Moore Ranch Environmental Report
RAI Response Summary

Question TR 2.2.3.1 Surface Waters

10288 W. Chatfield Ave, Ste 201 Littleton, CO 80127-4239
URANIUM ONE	
Figure CR3.4.3.3-1. Location Map 60 Sand Monitor Wells Moore Ranch Permit Area, Wyoming	
By: EPL Checked: HD File ID: figCR34332lsrf Date: 7/29/09

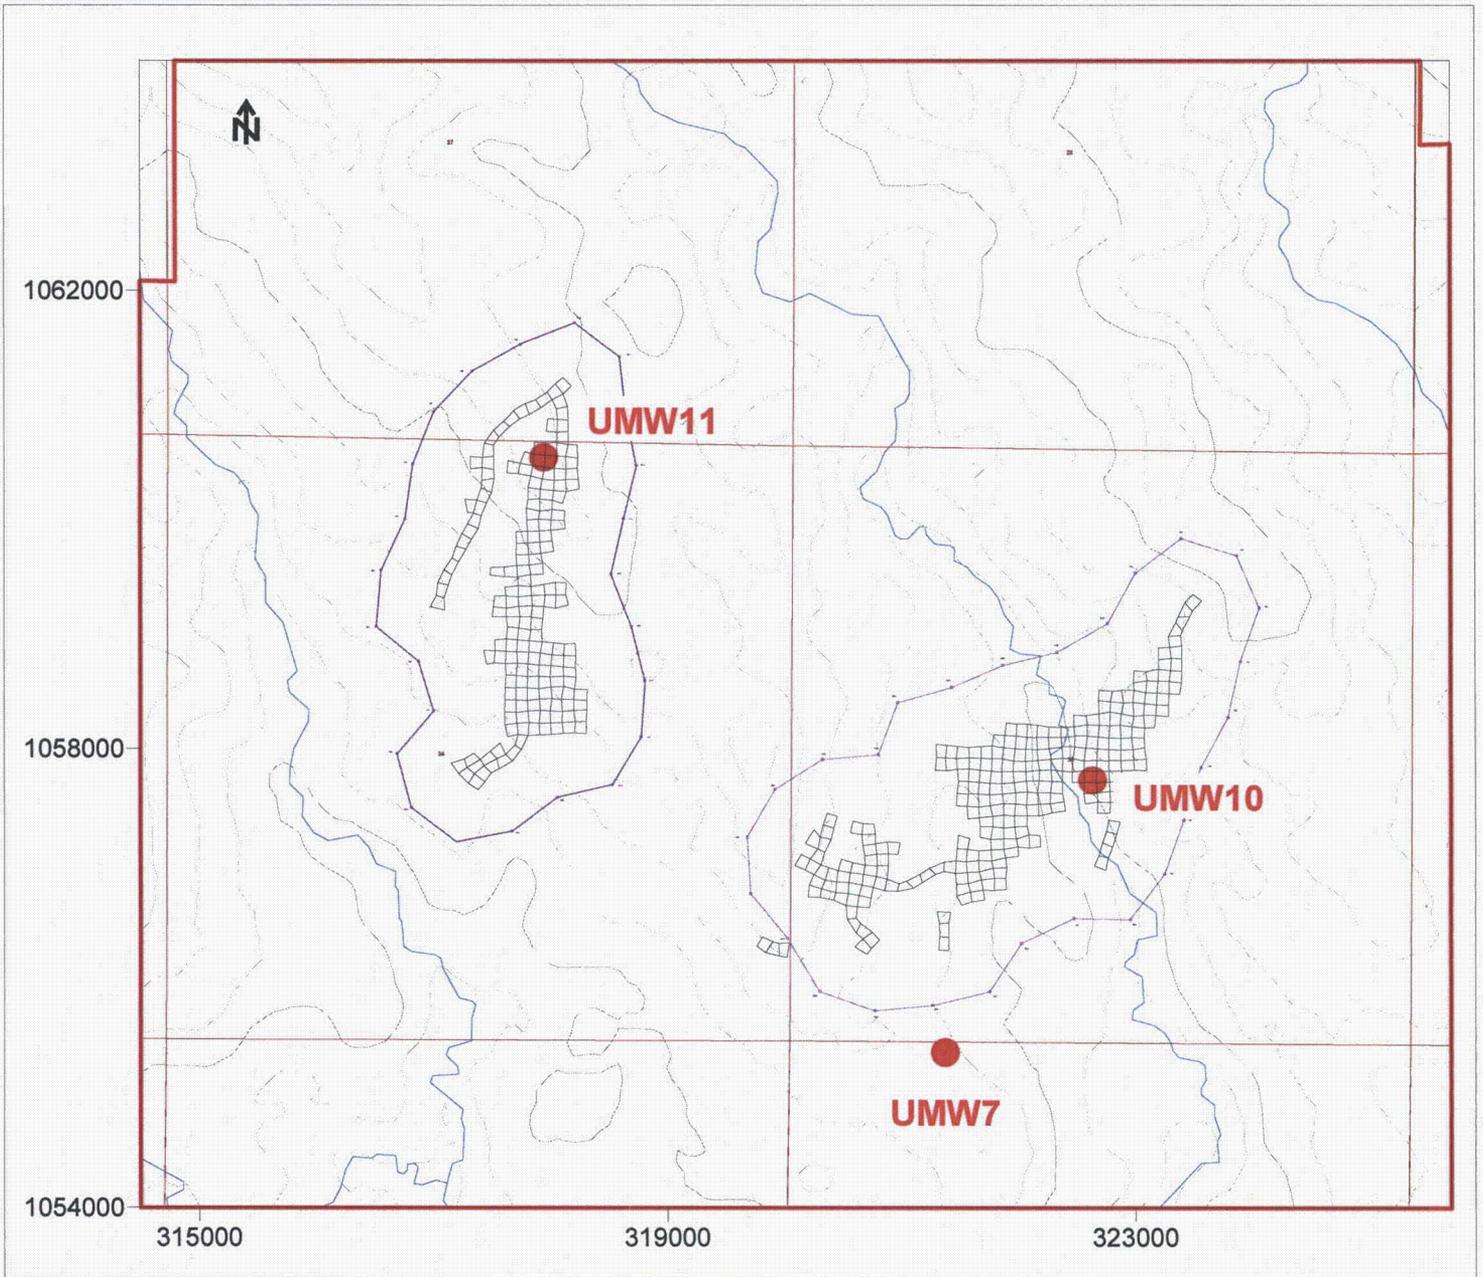
Since the 60 sand is now considered the underlying aquifer to the production zone in areas where the 70 and 68 sands coalesce, all available groundwater quality data for the 60 sand should be provided and discussed. If sufficient data are not available to characterize groundwater quality in the 60 sand in the project area, additional groundwater sampling should be undertaken to provide such data.

Three additional monitor wells have been drilled and completed in the 60 Sand within the project area. The locations of the wells are shown on Figure CR3.4.3.3-1. Initial samples were collected from these wells in May 2009. A total of four quarterly rounds of water quality samples will be collected to evaluate water quality for the 60 Sand representative of the Moore Ranch License Area. One of the wells (UMW-10) is located within proposed Wellfield 2 in the area where the 72 and 68 Sands coalesce. Results of the initial sampling of the 60 Sand are summarized in the following table.

**Figure CR3.4.3.3-2a Projected Class of Use
80 and 72 Sand Monitor Wells
Moore Ranch Permit Area, Wyoming**

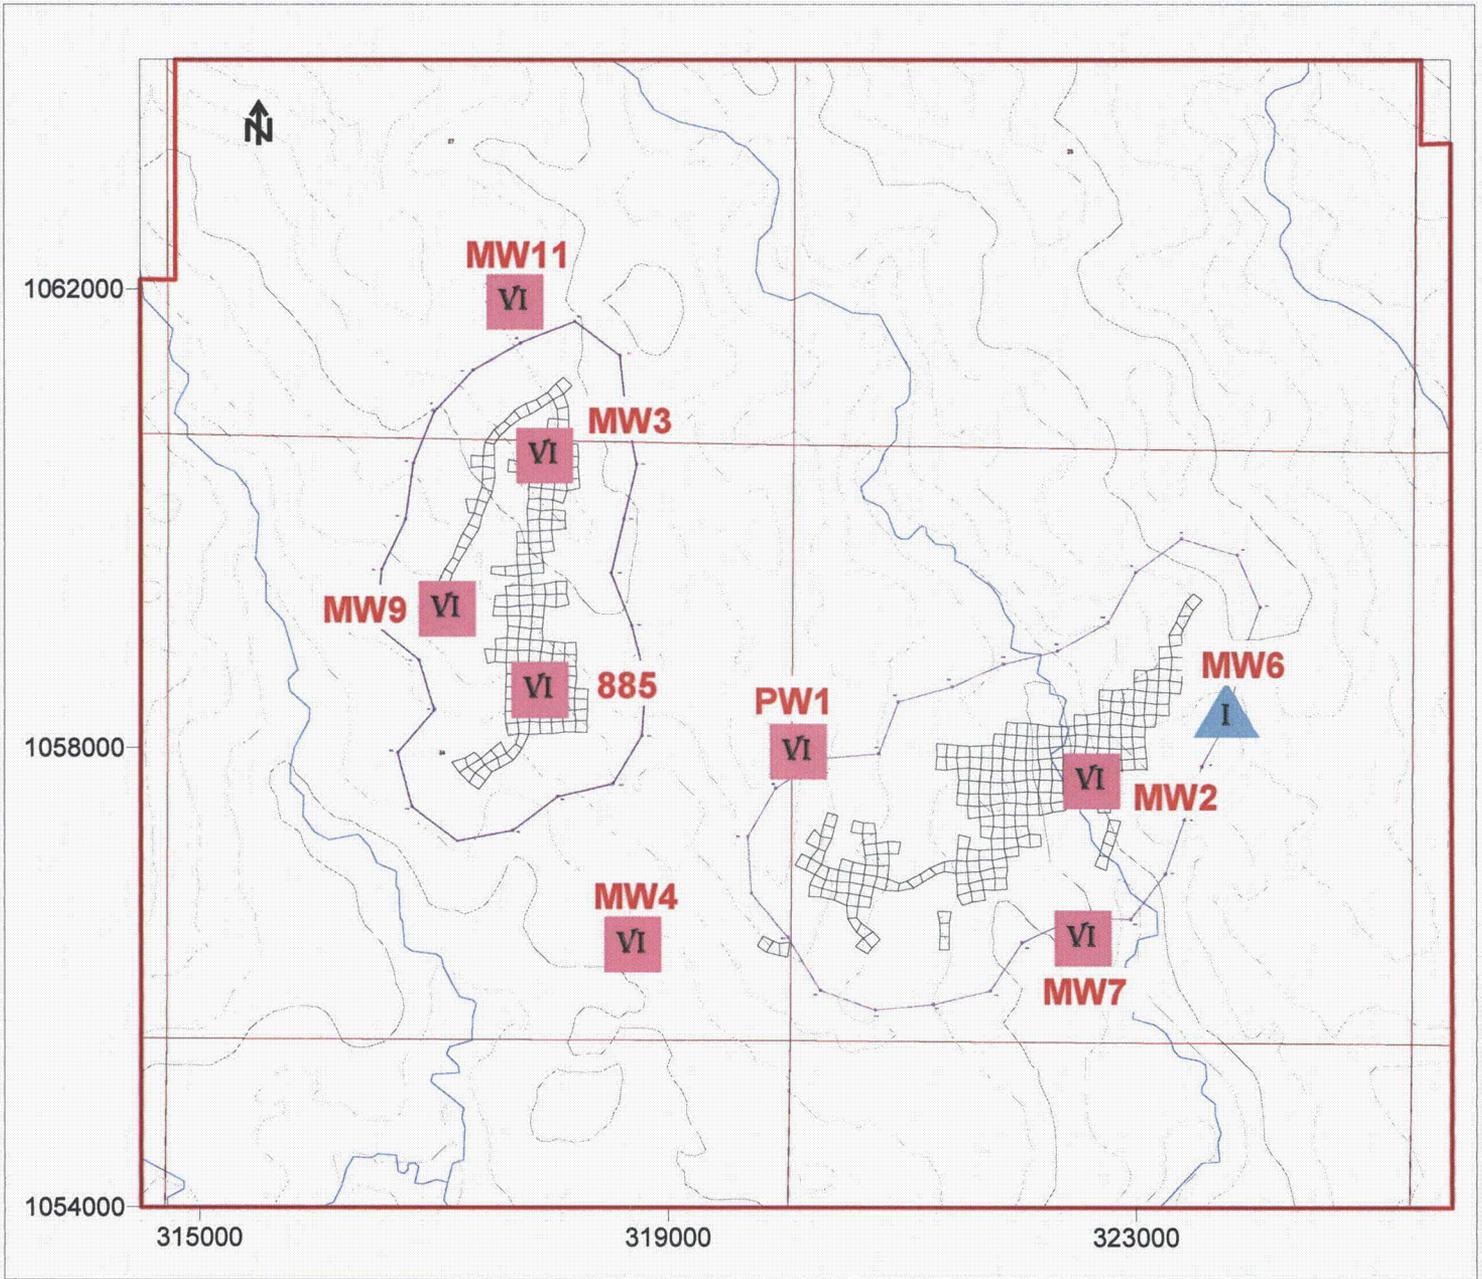
Based on available water quality data, the WDEQ class of use for 72, 70, 68, and 60 sands within the project area should be clearly illustrated.

A set of figures has been prepared that identifies the projected WDEQ class of use for the 60 through 72 Sands within the project area, based on the available monitor well water quality data (Figure CR3.4.3.3-2a through 2d). A separate figure is presented that indicates the projected class of use of four private un-permitted stock wells within the License Area that have been sampled by EMC Figure CR3.4.3.3-2e. The completion zones for these wells are estimated from pump depths and projection from site cross sections. Also included on the figure is the projected class of use for two Conoco monitor wells that are completed across multiple aquifers.

Petrotek	10288 W. Chatfield Ave, Ste 201 Littleton, CO 80127-4239
	URANIUM ONE
Figure CR4.4.2.1-1a	
Location of Private Wells (non CBM)	
Within 2 Miles of Moore Ranch Permit Area	
By: EPL Checked: HD File ID: figCR44211.srf Date: 7/29/09

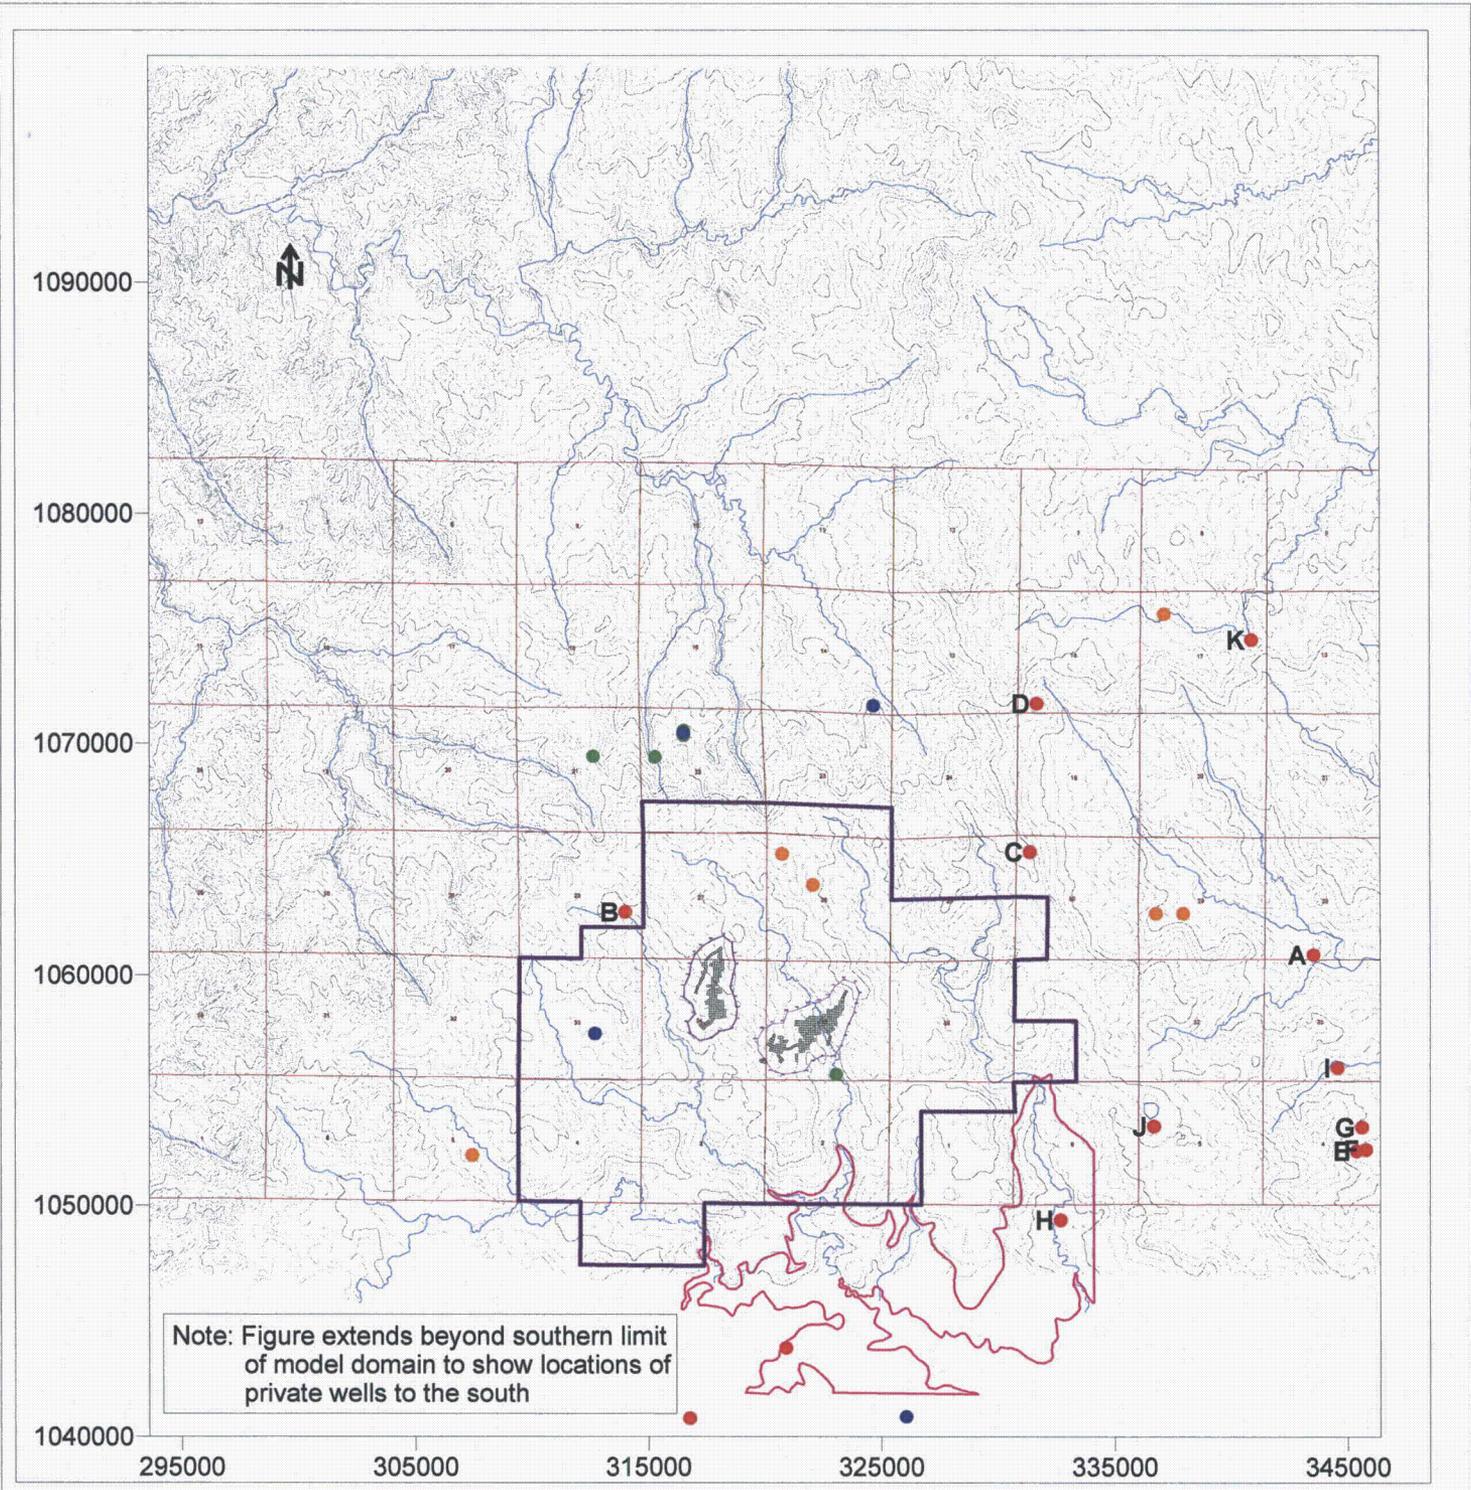
A figure depicting predicted drawdowns throughout the model domain should be provided. The location of all wells expected to be screened in the 70 and underlying 68 sands should be superimposed on the figure. Based on this figure, all existing wells in the 70 or 68 sand potentially impacted by drawdown induced by production or restoration pumping should be identified.

Figure CR4.4.2.1-1a shows the location of wells within 2 miles of the License Area that are completed in the Upper Wasatch Sands (Sands 40 through 80). A set of figures has also been prepared showing the predicted drawdown throughout the model domain at the end of production operations, the end of restoration of Wellfield 1, and the end of restoration of Wellfield 2 (Figures CR.4.4.2.1-1b, -1c and -1d, respectively). To the extent the data are available and reliable, existing wells completed in the 70 or 68 sand (excluding monitor wells) potentially impacted by drawdown induced by production or restoration are shown on the figures and cross referenced to Table CR4.4.2.1-2b (below).
